PROPOSED CHANGE NOTICE

2445-13

RE: AURORA FOOD STORE
 2000 ANAQUOD ROAD
 REGINA, SK
 Commission No. 2445

RE: Building Permit / Misc Modifications

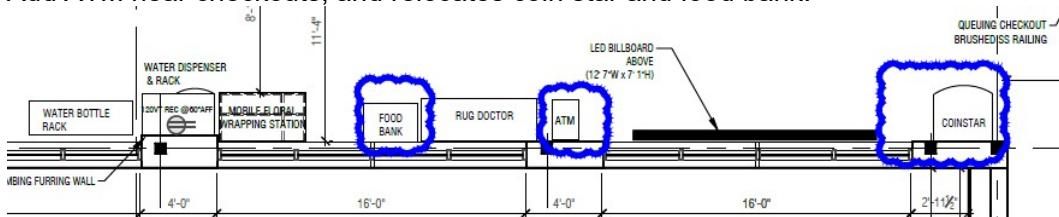
- e) Add full height 3 5/8" wall <A2> behind refrigerated case south side of Butcher Shop. Modify location of handsink. Provide white FRP at Butcher Shop side. Provide stainless steel cap at end of wall.

1
MP-01A WATER AND VENT FOR NEW SINK
SCALE: 1/8" = 1'-0"

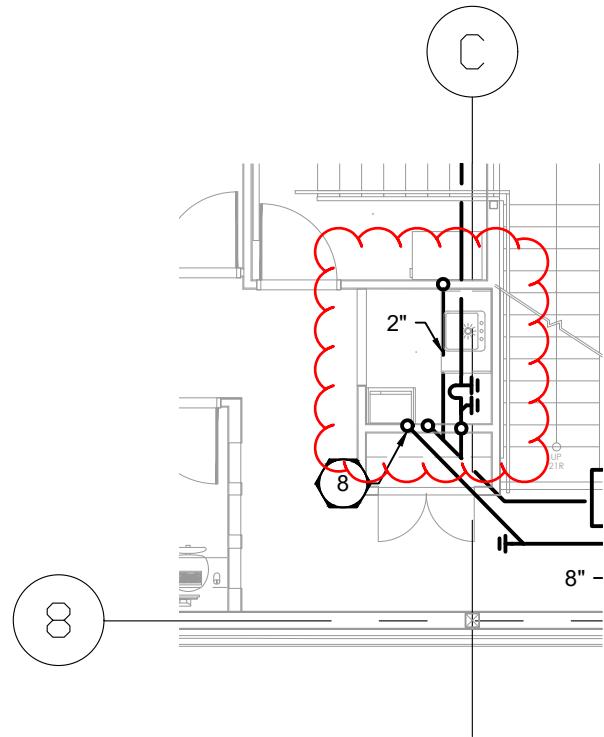
1. Supply and install a new staff sink [SK-1], drain, vent, hot and cold domestic water lines in the main floor employee area as shown on mechanical revision drawings MP-01A and MP-01B.

WATER AND VENT FOR RELOCATED SINK

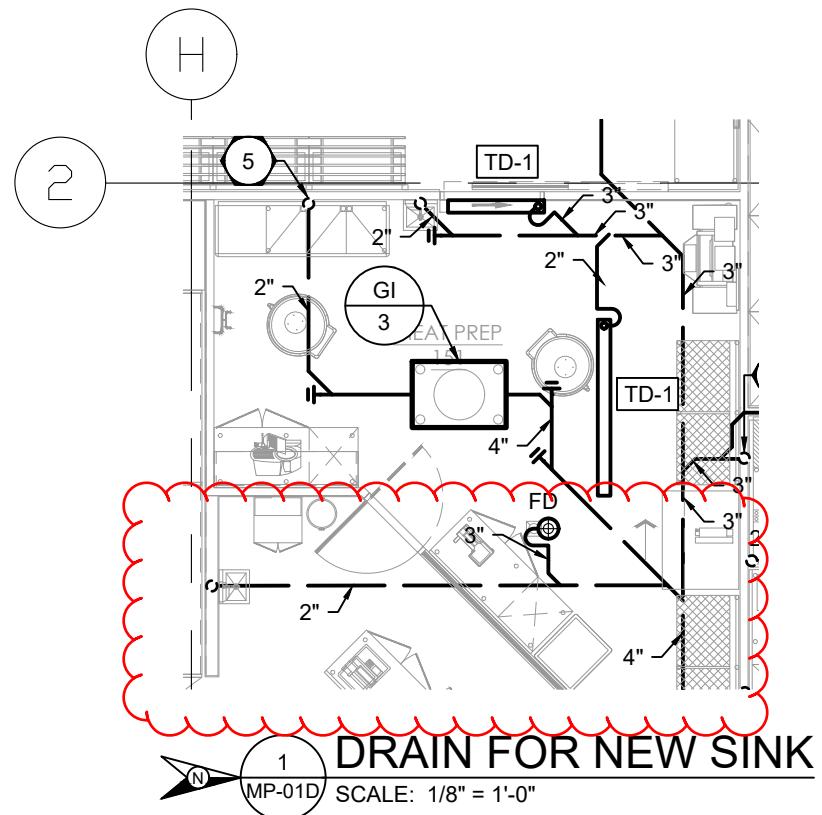
2. Revise the location of the hand sink, drain, vent, hot and cold domestic water lines within the Butcher Shop as shown on mechanical revision drawings MP-01C and MP-01D.

FLOOR PLAN - LIGHTING
COMMISSION NUMBER: 2445
SHEET NUMBER: E1.0

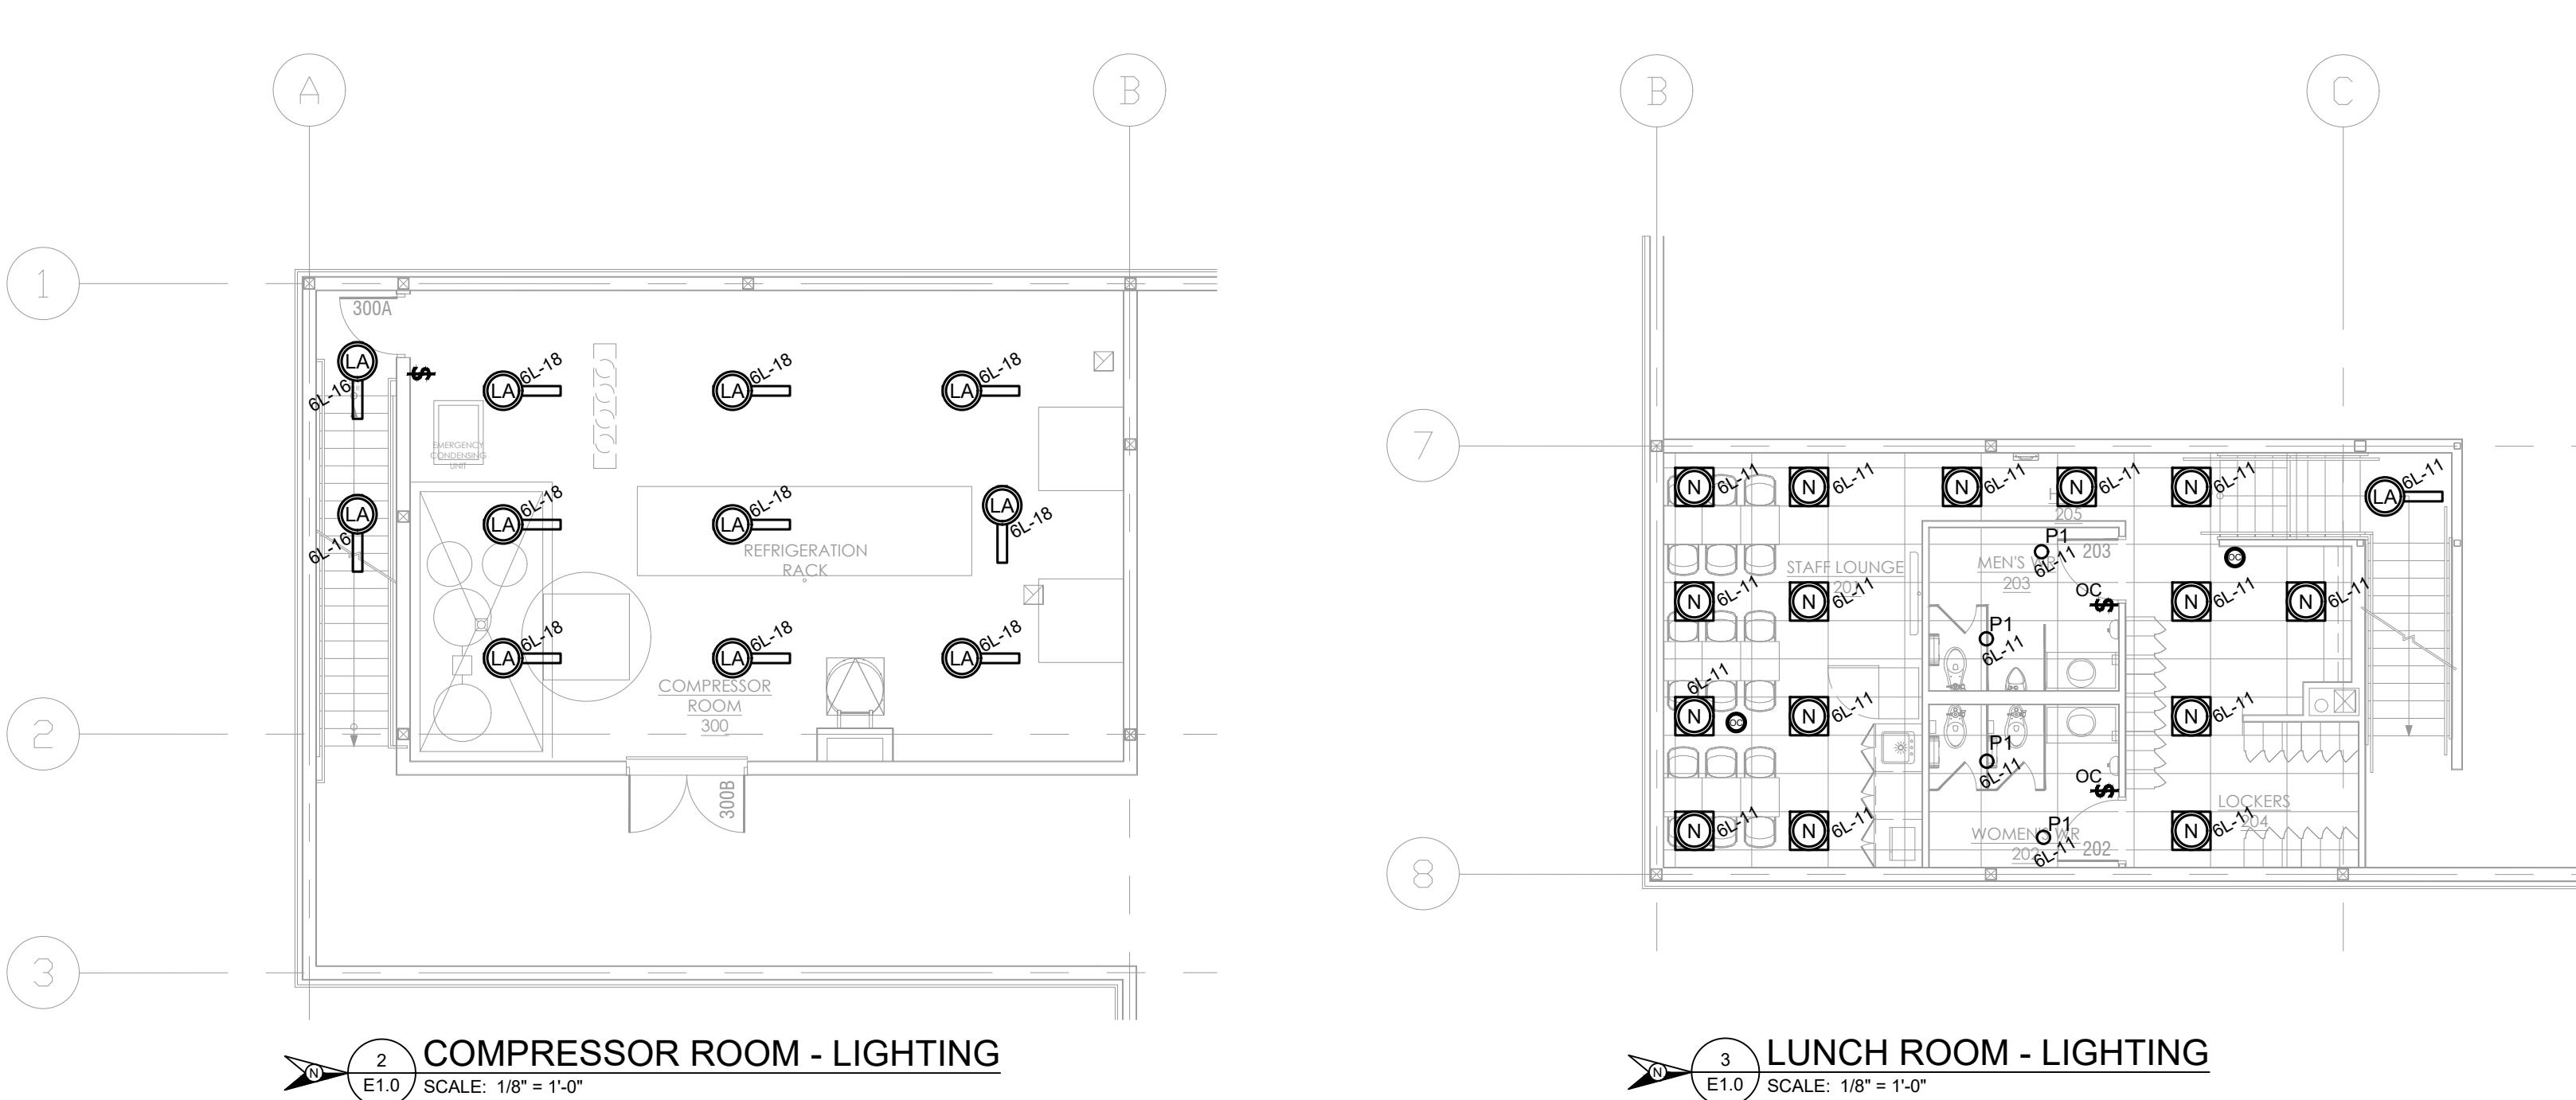
1. Refer to attached drawing E1.0 for one(1) additional type 'F1' light fixture added to new 'Staff 117'.
2. Refer to attached drawings E0.2 and E2.0 for one(1) additional receptacle c/w dedicated 15A-1P circuit for microwave.

3. Refer to attached drawing E1.0 for revised lighting layout in the 'Butcher Shop 150' and 'Seafood Prep 137' areas.
 - 3.1. Ten(10) type VT light fixtures are removed. Provide credit to owners for the removal these light fixtures from the project.
 - 3.2. Ten(10) type F1 light fixtures are added to 'Butcher Shop 150' and 'Seafood Prep 137' areas to replace the previous Type VT fixtures.

E2.0 SCALE: 1/8" = 1'-0"

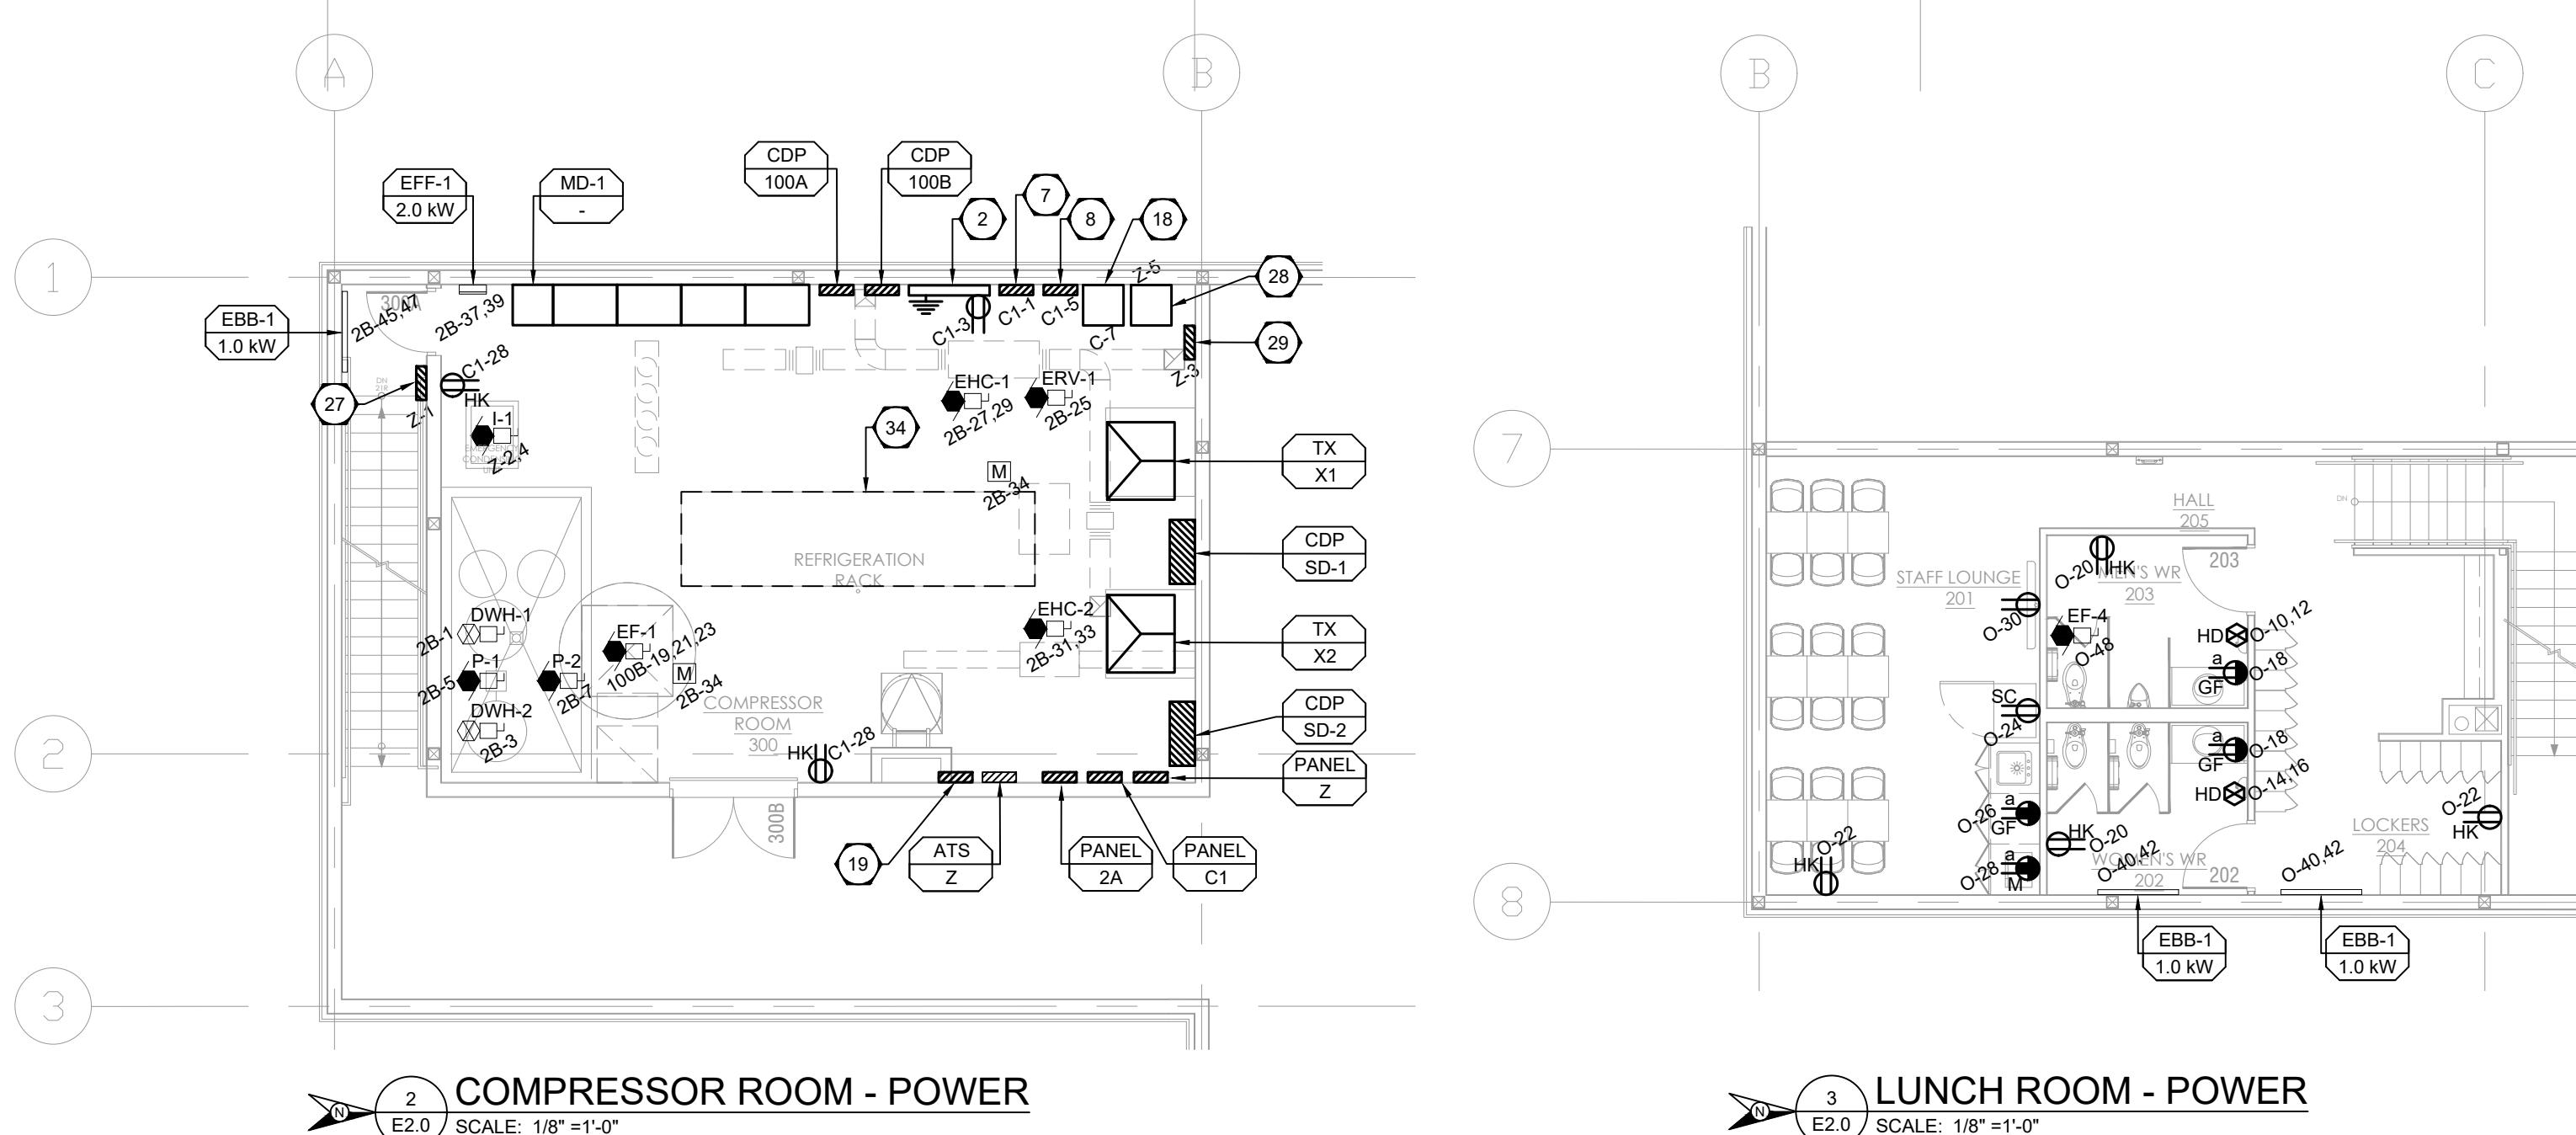
4. Refer to attached drawings E0.3, E2.0 and E5.0 for additional receptacles, circuits and data for owner equipment.
 - 4.1. One(1) receptacle and one(1) 15A-1P circuit is added for the ATM machine.
 - 4.2. One(1) 15A-1P circuit is added for a dedicated circuit to the Coinstar machine.
 - 4.3. One(1) 15A-1P circuit is added for a dedicated circuit to the Water Dispenser.
 - 4.4. Specific note 16 is added to drawing E5.0 and states the following:
 - 4.4.1. "PROVIDE AND INSTALL ONE 1/2" EMT CONDUIT C/W PULLSTRING FROM SERVER RACK IN IT ROOM FOR ATM MACHINE DATA."
